City of Arvada

City Council Agenda

JUNE 3, 2024

SUBJECT: R24-059, A Resolution Authorizing Change Order No. 2 to the Construction Management Agreement For Pre-Construction & Construction Services for the Meyer's Pool Replacement Project

4 POOL WEST
1/8" = 1'-0"

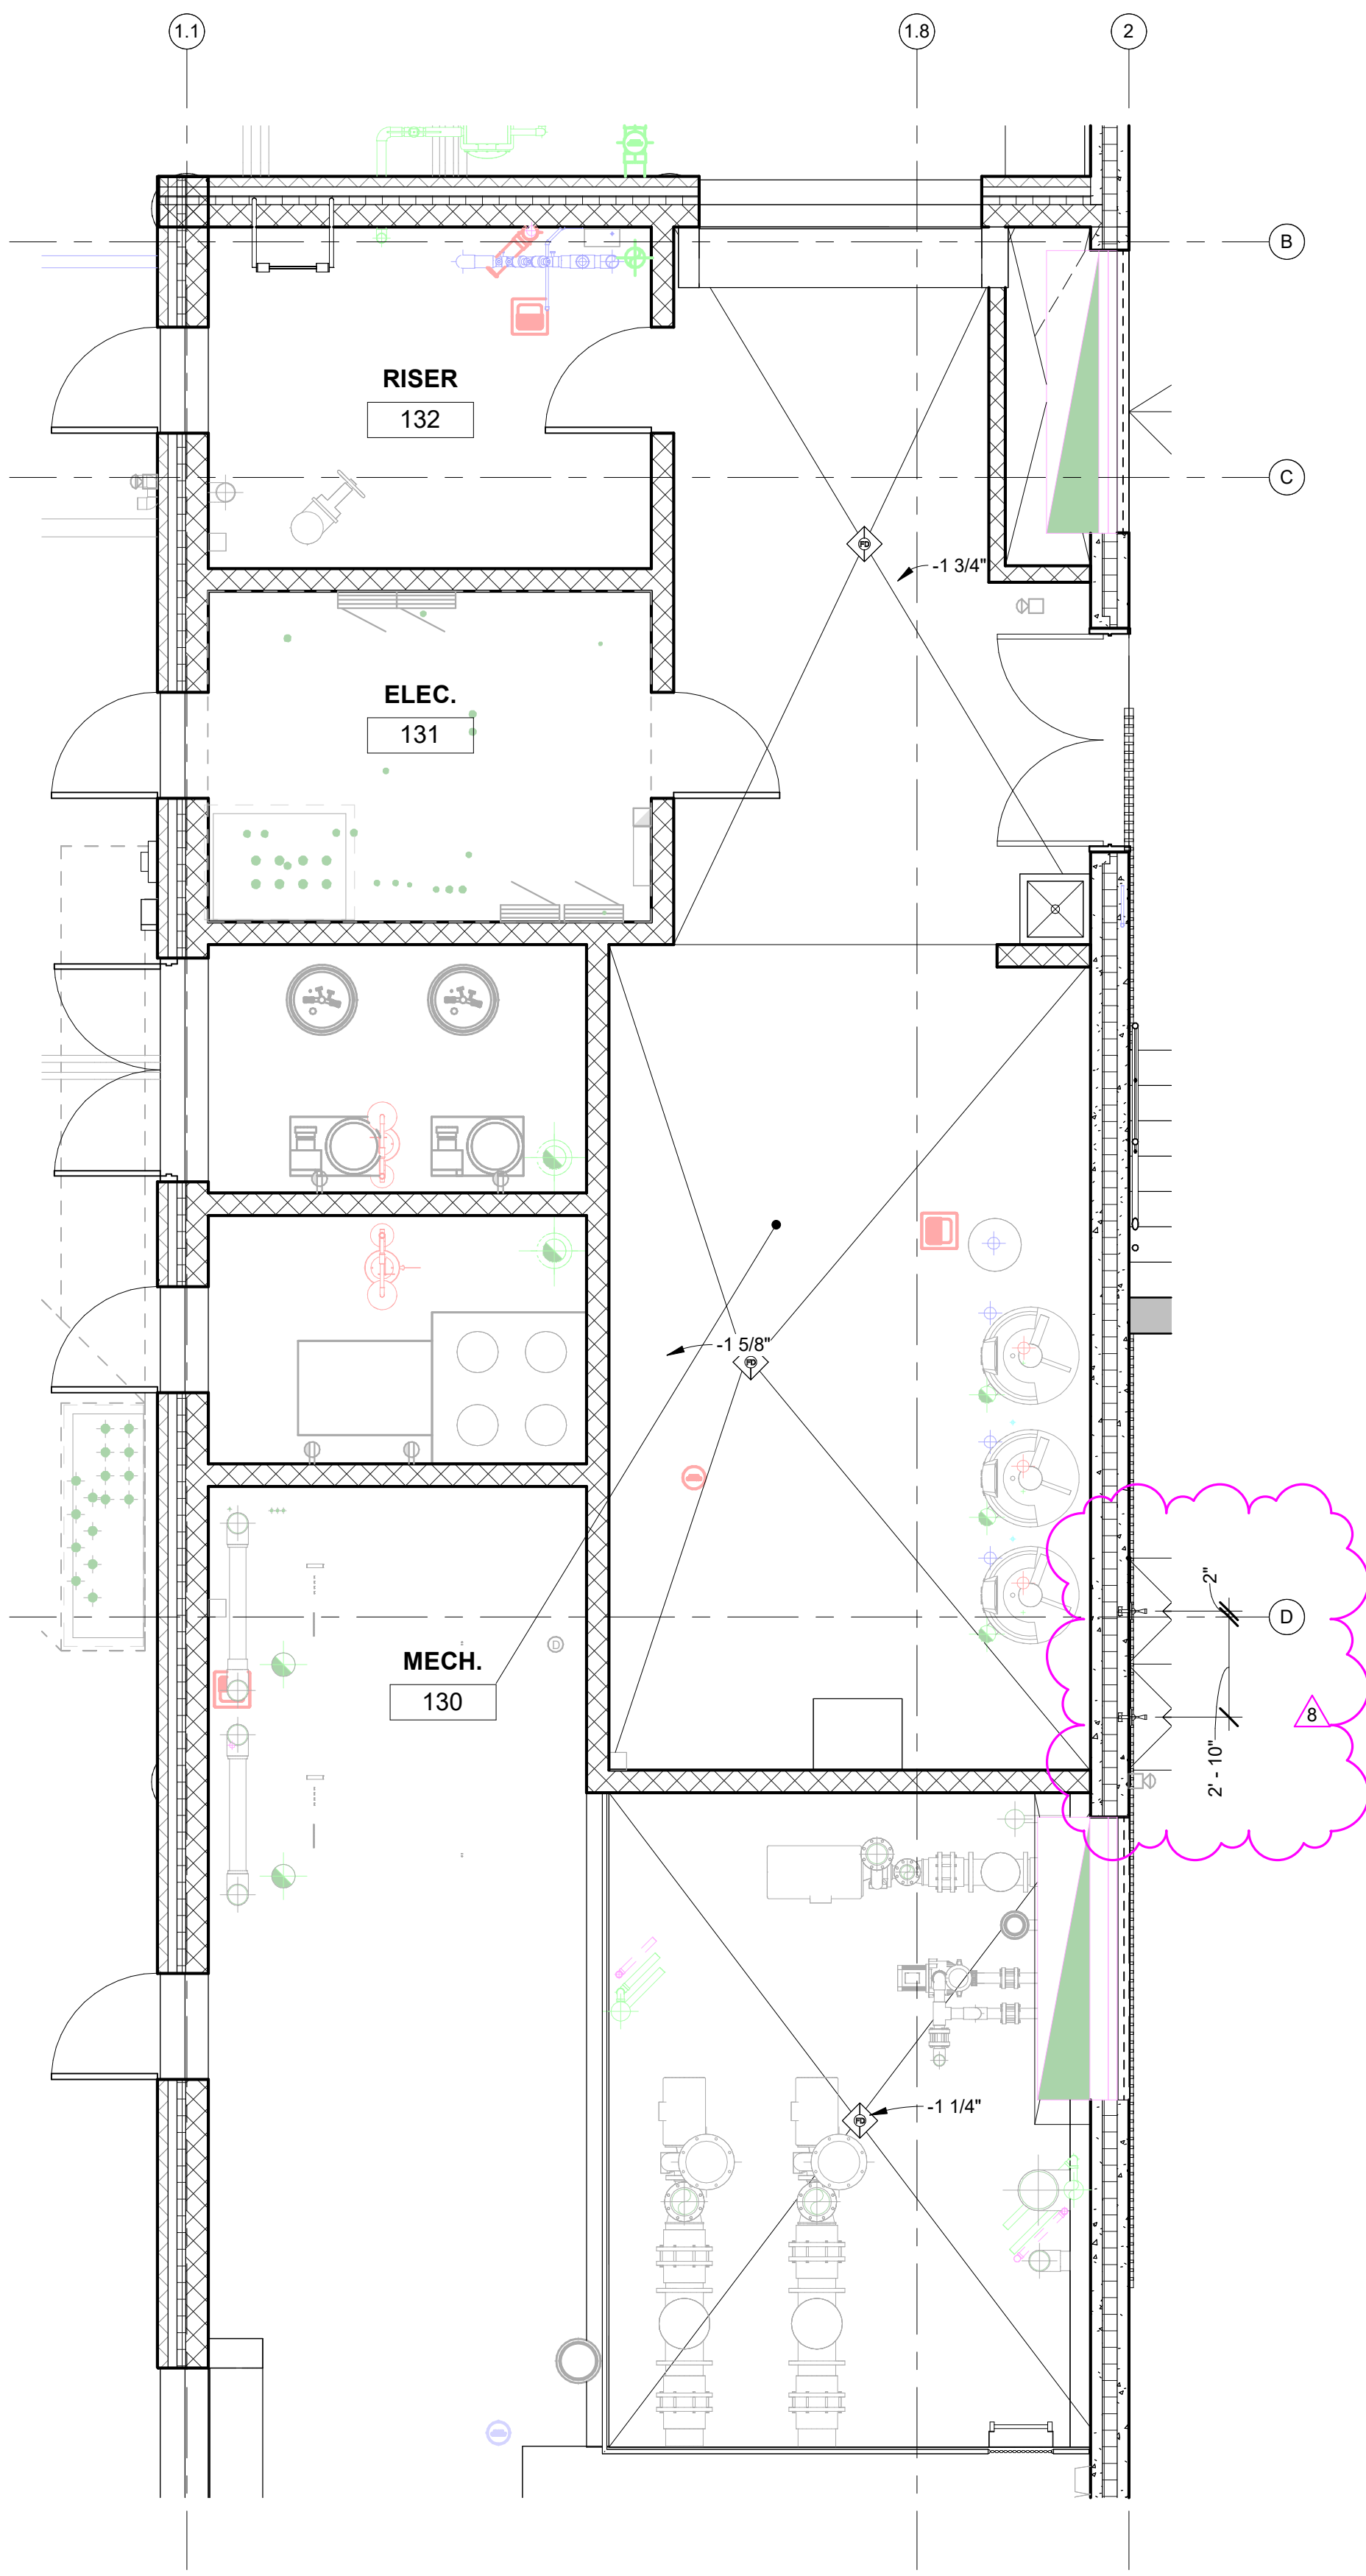
SHEET	DESCRIPTION
A210	Detail 4 – Pool West elevation: Revise wall tile at pool deck showers as indicated.
A405	Detail 1 – Mech and Pool Storage Enlarged Plan-1, PROVIDE location of pool deck shower plumbing.
A409	Various Details – PROVIDE dimensions for Diving Tower as indicated.
S110A	Plan revisions – Revised location for 1M spring board platforms, RFI 110 and 130 Revisions to CMU walls.
S110B	Plan revision for RFI 130 – CMU Wall callout.
S120A	Plan Revisions – RFI 110 CMU wall revision, RFI 149 steel beam connection detail revision.
S130A	Plan Revisions – RFI 110 CMU wall revision,
S205	Plan views 3 and 4 – Revised platform layout and slab dimensions. Detail 5 - Additional information provided to support the dive platform structure.
S206	Detail 12 – Revised platform layout and slab dimensions. Details 13 and 15 – revised dive platform slab thickness.
S211	Elevation 1 – Revised precast wall thicknesses to match precast shop drawings.
